February 7, 2008

RE: STARK COUNTY
WASHINGTON TOWNSHIP
OAKHILL MANOR, INC.
4466 LYNNHAVEN AVE.
NPDES #3PR00177

Clarifier – note solids

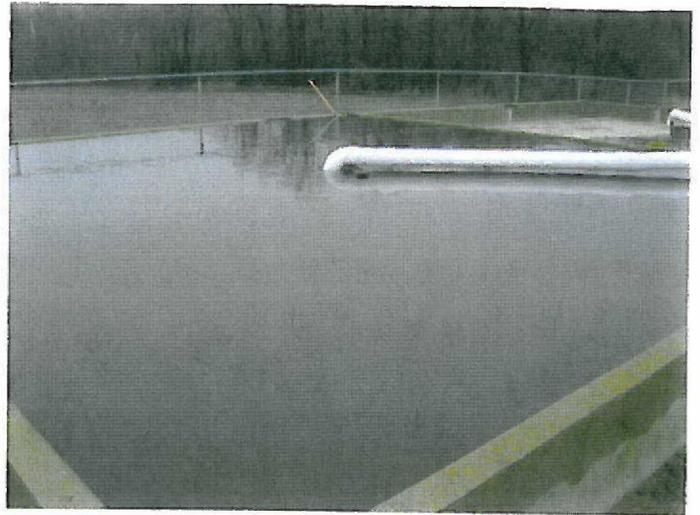
At the time of the inspection, the mixed liquor in the aeration tank has a good color. There was an excessive amount of solids on the surface of the clarifier. The elevation of the skimmer needs to be adjusted so that these solids are returned to the aeration tank.
